HISTORIC AND DESIGN REVIEW COMMISSION

March 17, 2021

HDRC CASE NO: 2021-076
ADDRESS: 406 N PINE ST
LEGAL DESCRIPTION: NCB 1373 BLK 1 LOT 8
ZONING: RM-4, H
CITY COUNCIL DIST.: 2
DISTRICT: Dignowity Hill Historic District
APPLICANT: Micah Deary/DEARY MICAH & KELLY A
OWNER: Micah Deary/DEARY MICAH & KELLY A
TYPE OF WORK: Construction of a rear accessory structure
APPLICATION RECEIVED: February 04, 2021
60-DAY REVIEW: Not applicable due to City Council Emergency Orders
CASE MANAGER: Edward Hall

The applicant is requesting a Certificate of Appropriateness for approval to construct a rear accessory structure at 406 N Pine. The proposed structure received conceptual approval on December 16, 2020, with the stipulation that complete construction documents be submitted for the Commission's review. The proposed primary structure received final approval at that hearing.

SITE PLAN
A100

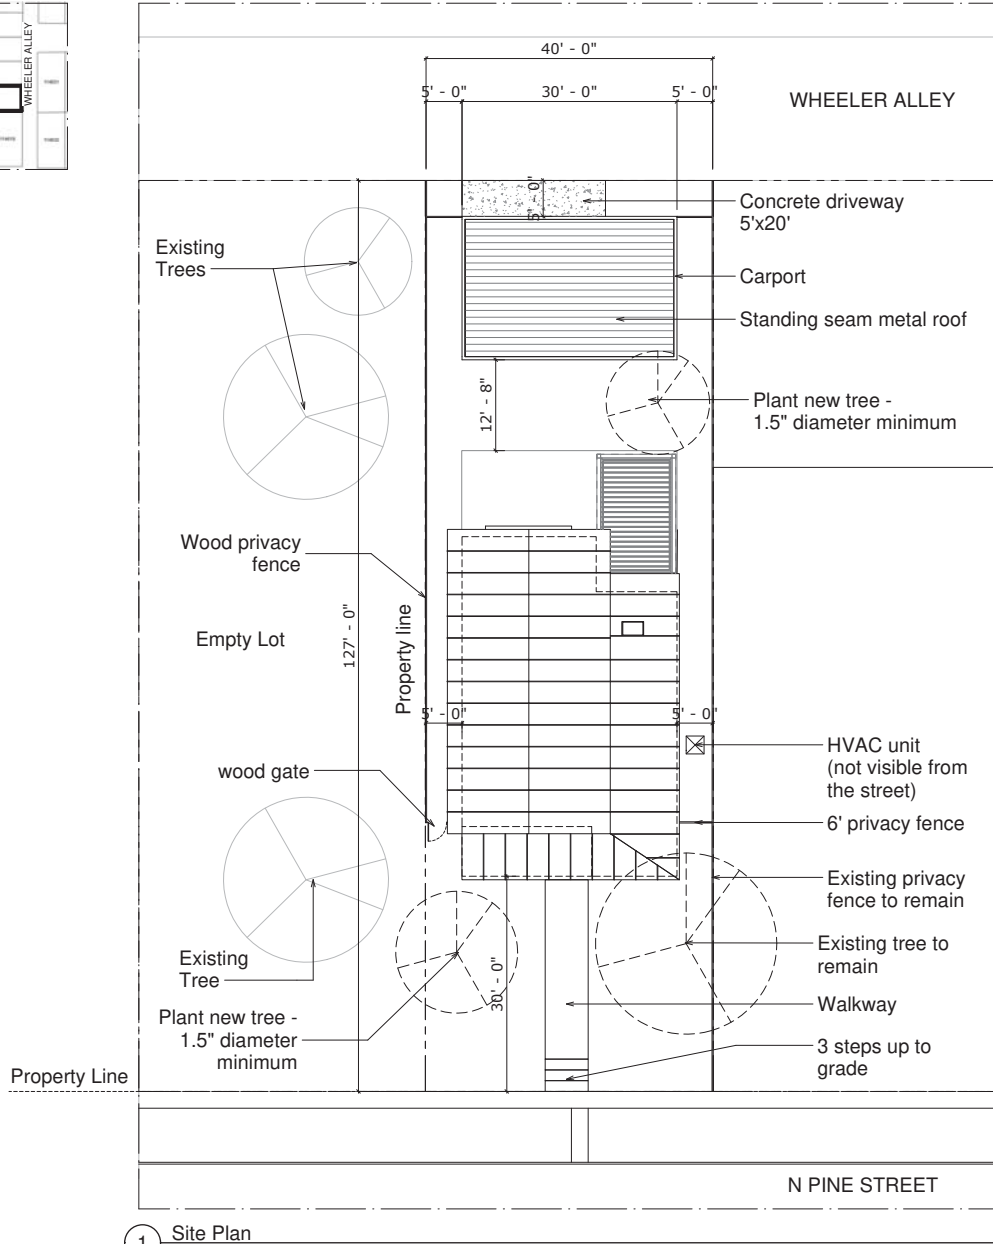
- b. ACCESSORY STRUCTURE – At the rear of the previously approved new construction, the applicant has proposed to construct an accessory structure to feature covered parking and a footprint of approximately 600 square feet. The applicant has proposed for the structure to feature an overall height of 9' – 6".

- c. ACCESSORY STRUCTURE (Massing)– The Guidelines for New Construction 5.A. note that new accessory structures should be designed to be visually subordinate to the primary historic structure on the lot in terms of their height, massing and form; and should be no larger than forty (40) percent of the primary historic structure's footprint. The primary structure on this lot (new construction) features a footprint of approximately 1,200 square feet. As proposed, the rear accessory structure features a footprint that is approximately fifty (50) percent of the primary structure's footprint. This is not consistent with the Guidelines; however, given that the primary structure on the lot is new construction and not a historic structure, staff finds the proposed accessory structure's footprint to be appropriate. Staff finds the proposed height of 9' – 6" to be appropriate.

- e. SETBACKS & ORIENTATION – The Guidelines for New Construction 5.B. note that the predominant garage orientation found along the block should be matches. Additionally, the Guidelines note that setbacks of new accessory structures should be similar to the setbacks of those found historically in the district. Staff finds the proposed accessory structure to be sited consistently with the Guidelines.

- f. DRIVEWAY – At the rear of the lot, adjacent to Wheeler Alley, the applicant has proposed to install a driveway to feature approximately twenty (20) feet in width. Wheeler alley features many formal and informal driveways with varying widths, profiles and materials. Generally, staff finds the propose driveway to be appropriate given existing, driveway profiles, widths and materials on Wheeler Alley; however, the applicant shall confirm to all development standards regarding aprons and driveway approaches.

- g. FENCING – The applicant has proposed privacy fencing at the rear of the lot in coordination with the proposed accessory structure. Staff finds the proposed fence to be appropriate and finds that it should feature a height no taller than six (6) feet.

- i. That proposed standing seam metal roof should feature panels that are 18 to 21 inches wide, seams that are 1 to 2 inches in height and a standard galvalume finish. A crimped ridge seam is to be used and if a ridge cap is requested, it must feature a low profile and be approved by staff prior to installation. A dark gray color may be used on the rear accessory structure's roof to match that approved on the primary structure.
- ii. That the proposed fencing not exceed six (6) feet in height, as noted in finding g.
- iii. That the applicant adhere to all development standards for the proposed driveway, including apron profiles.
